TOLEDO - LUCAS COUNTY PLAN COMMISSIONS

DATE: July 14, 2023
REF: PUD-6002-23

TO: President Matt Cherry and Members of Council, City of Toledo
FROM: Toledo City Plan Commission, Thomas C. Gibbons, Secretary
SUBJECT: Request for a Planned Unit Development for a 28-unit villa development at 3322 Schneider Road.

SITE PLAN

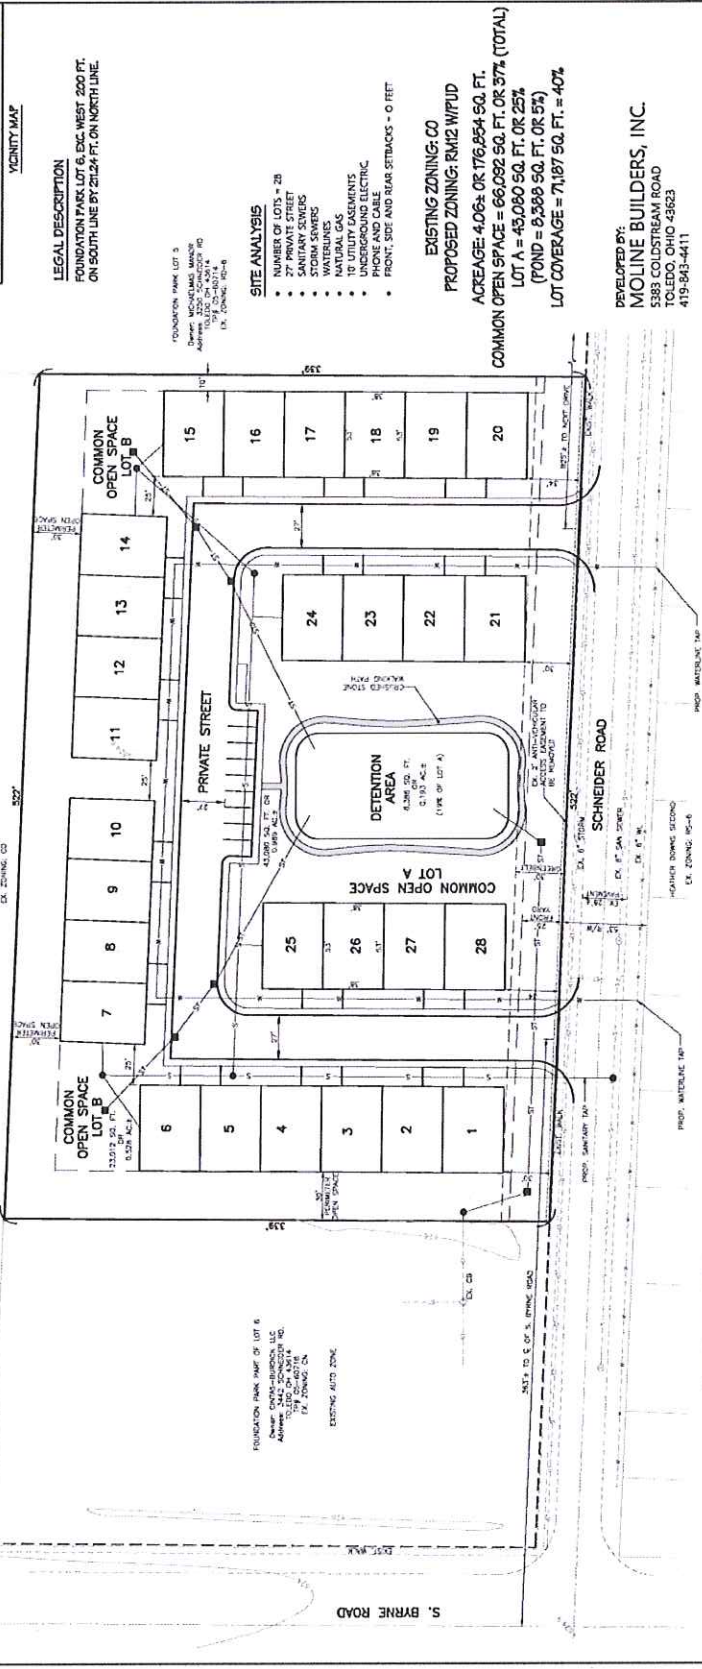
5. A new 8-inch diameter water main has been constructed in Schneider Road; the 6-inch diameter water main shown on the submittal has been abandoned.
6. The private fire line loop for Heather Cove shall have a single owner that will be responsible for maintenance of the private fire line loop. In lieu of this requirement, there shall be an agreement, acceptable to the City of Toledo, addressing the shared responsibility between property owners for the installation, maintenance, and billing of the private fire line.

7. Further comments regarding the proposed private water main and/or service lines will be provided by the Division of Water Distribution.
8. Plans show a connection to a private storm sewer on the west side of the property. The City of Toledo cannot approve plans or give permission to use this storm line without a written agreement and maintenance plan between the two property owners. Suggest connecting into an existing structure or installing a new structure on the existing public storm sewer that runs parallel to the property along Schneider Road.

24. Sheet 1/1:
 - a. Proposed water main shall connect to the existing 8" water main in the north (WB) lane of Schneider (existing 6" water main on the south side of the road has been abandoned).

- b. Proposed water main shall maintain 10-foot horizontal clearance from proposed storm and sanitary sewers.
 - c. Include 2023 Water Notes for Large Services City (attached to email) on the plans.

- d. 45-degree bends would be preferred over 90-degree bends on the north side of the development.

28. Transportation requires an outer radial corner at the street corners inside the development (90-degree outer street corner is not permitted).
